## UNITED STATES ENVIRONMENTAL PROTECTION AGENCY

Draft Spring 2012 Bank Conditions Monitoring Report for the Former Plainwell Impoundment and Plainwell No. 2 Dam Area at the Allied Paper, Inc./Portage Creek/Kalamazoo River Superfund Site (August 2012)

## ATTACHMENT: Preliminary Sketch RA 10a, Area where rock should be installed to prevent erosion.

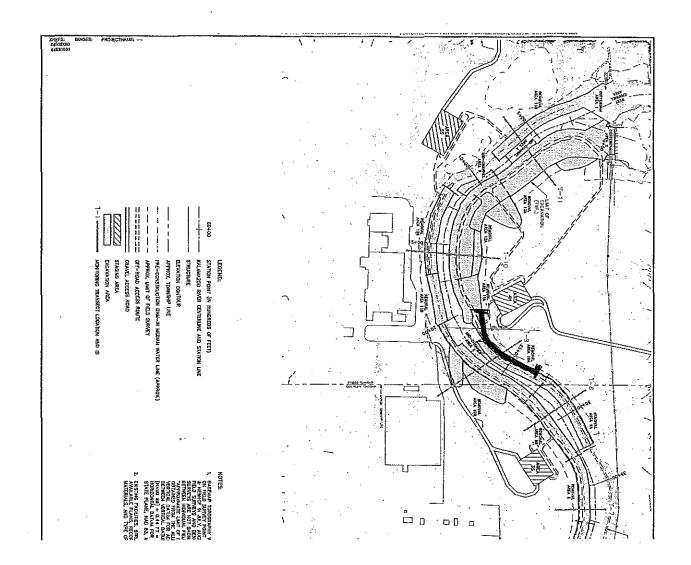
- 1. No significant issues of concern were identified upstream of US 131.
- 2. a) We observed some areas of continuing erosion in the former Plainwell Impoundment area that are between the US 131 bridge and the pipeline crossing that should be treated with rock. Specifically, RA 6B and 10A need to be addressed. These areas do not have stable banks and continue to erode. Given the constricted stream channel width, it is necessary to provide continuous rock protection along the water line and up the slope to the bankfull elevation (2-Year Storm Water Elevation). In addition, Georgia Pacific, LLC (Georgia Pacific) must replace the rock cover at RA 10B since we observed exposed liner in RA 10B during the joint visit on August 30, 2012.

Corrective actions should occur as soon as possible. A stable slope and toe armoring will be necessary. We recommend that willow stakes and other tree or shrub plantings be placed in this reconstructed slope and if necessary, irrigated during July and August and other periods with abnormally dry conditions until the plantings are well established.

Rock used throughout should be appropriately sized and graded river rock or field stone to resist the erosive force.

To help in the planning process, we have attached a preliminary sketch for RA 10a. The sketch indicates that new rock will be placed beginning at a point upstream of the pipeline crossing, where the design rock terminates, to a point downstream of the pipeline crossing. The exact area will need to be confirmed in the field by the State, EPA, and Georgia Pacific.
